23048 - DOTA - HNL PASS/ID OFFICE RENOVATION

PROJ NO. CO1322-63

ADDENDUM #2

DATE: 03/10/23

Rendering - WELLNESS

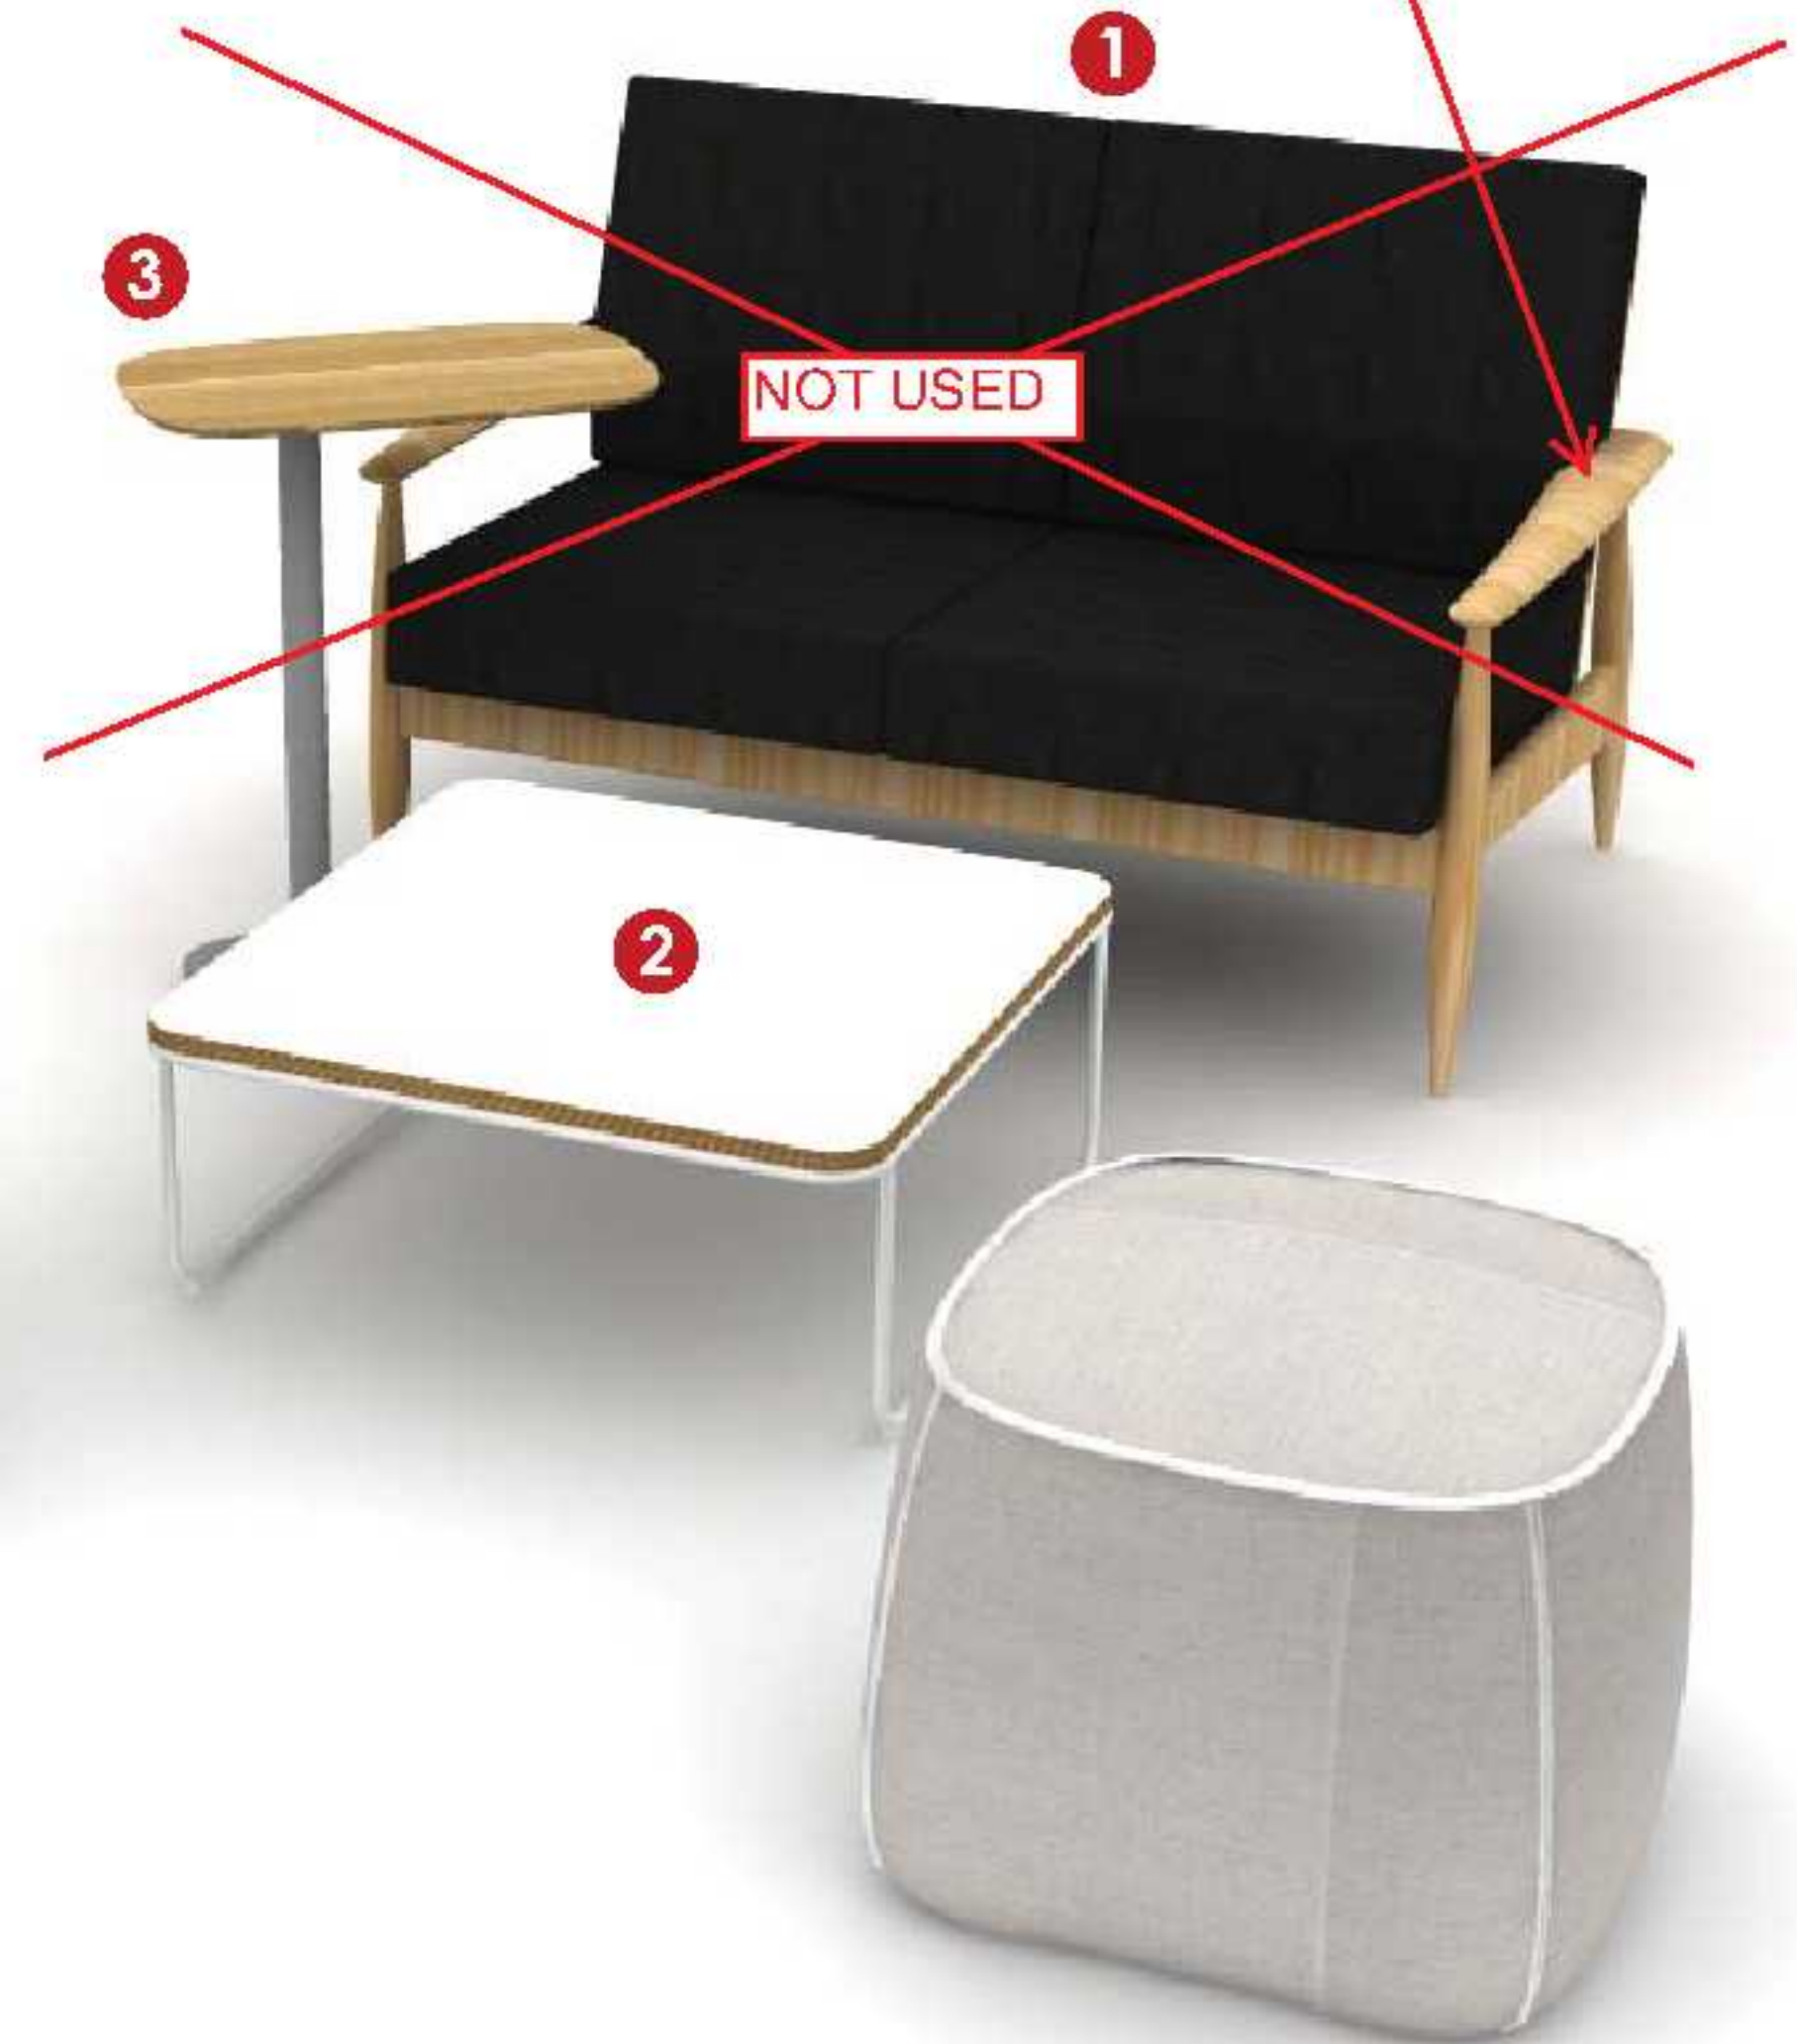
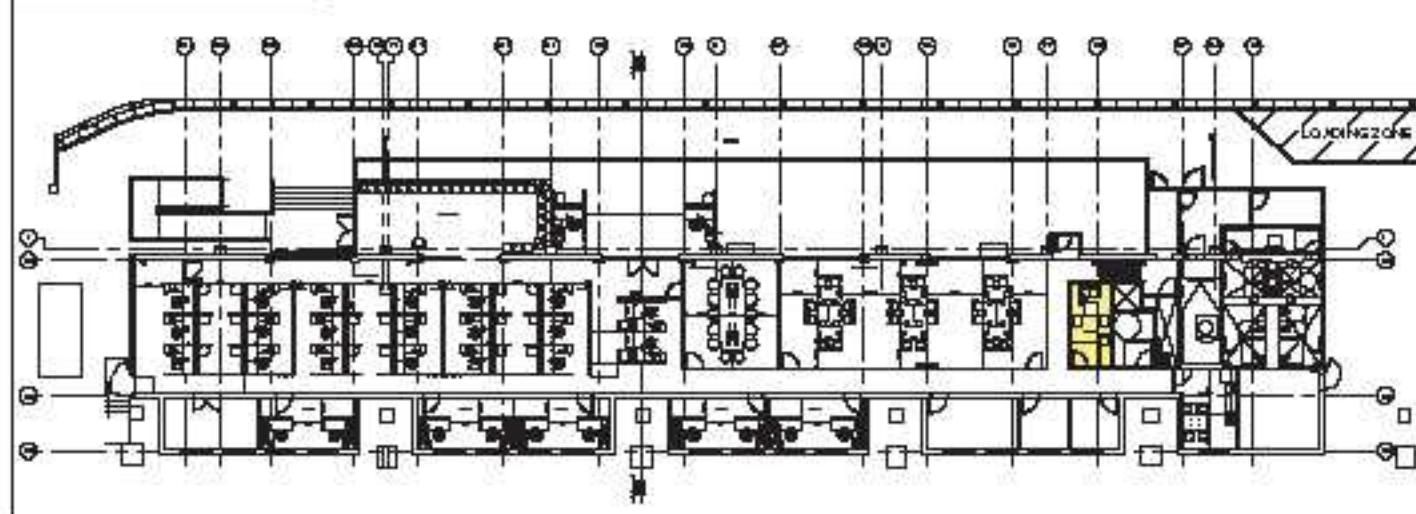
Please provide sofa similar. Sofa shall be full back w/arms on both sides. Support can be metal or wood.

Prefer sofa with fabric arms. See image on left for reference.

Rendering - OFFICES 1-5 TYPICAL (OPTION 2)

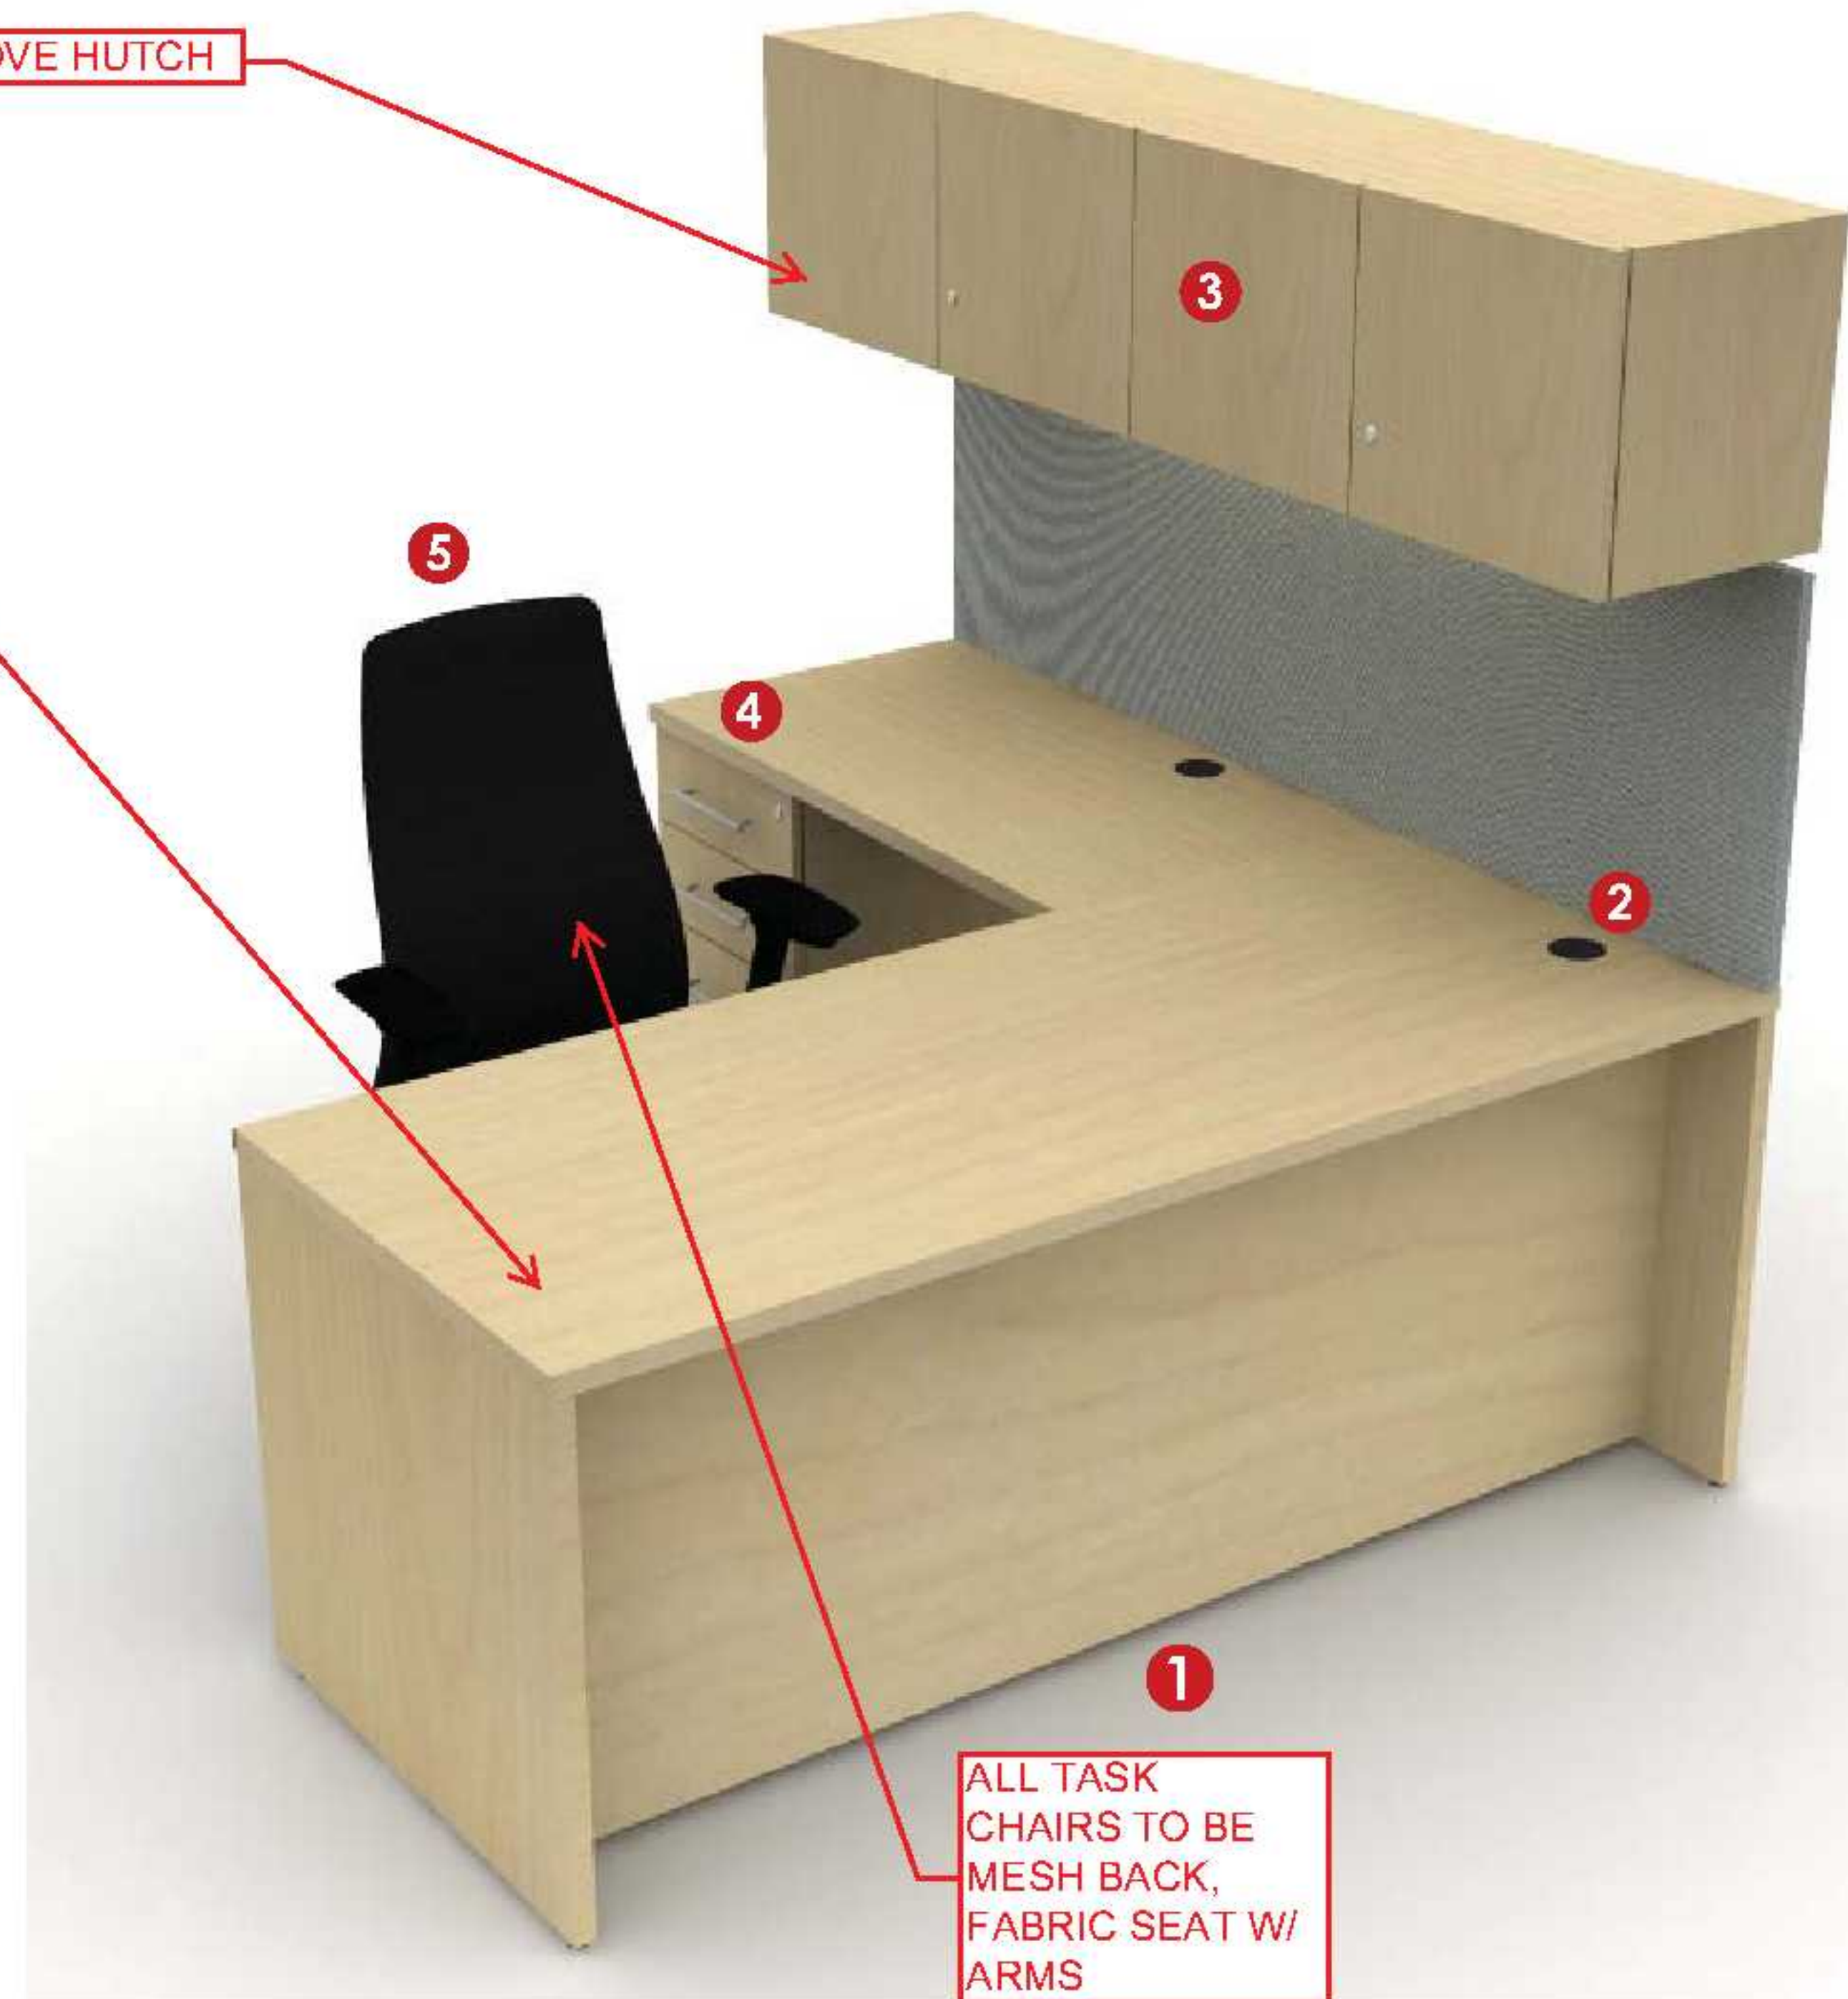
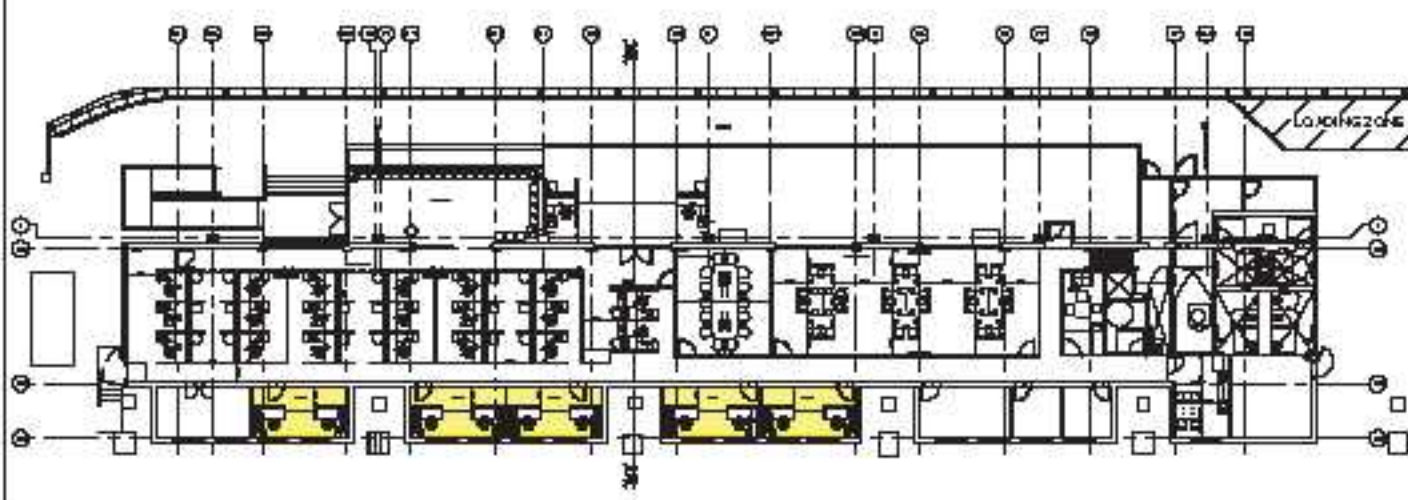
MAKE WORK SURFACE
HEIGHT ADJUSTABLE &
POWERED, C-LEG
TYPE. POWER TO BE
120V. PLEASE ALSO
EXTEND MAIN WORK
SURFACE TO 80" MIN.

- POWER MODULE TO
BE STANDARD PADDLE TYPE.
- TOTAL LIFT CAPACITY SHALL
BE 250 LBS MIN.
- INTEGRATED POWER MODULE
-

REMOVE HUTCH

ALL TASK
CHAIRS TO BE
MESH BACK,
FABRIC SEAT W/
ARMS

Rendering - BREAKROOM

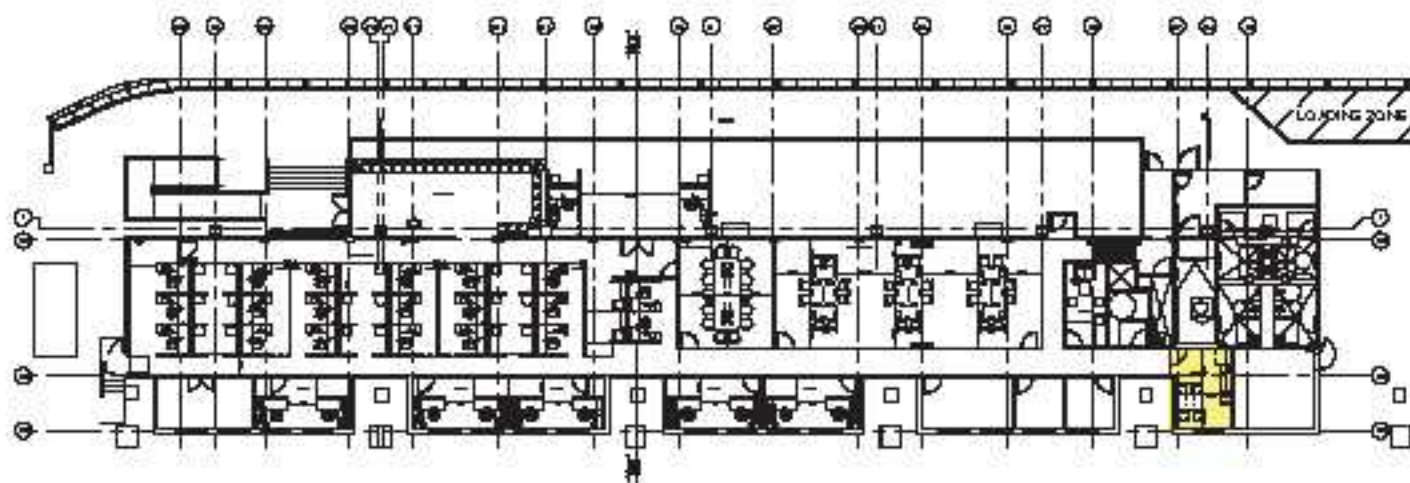
PLEASE PROVIDE
STANDARD HEIGHT
TABLE AND CHAIRS FOR
ADA REQUIREMENTS.
COUNTER HEIGHT TO BE
36" MAX. PLEASE ALSO
PROVIDE NESTING TYPE.
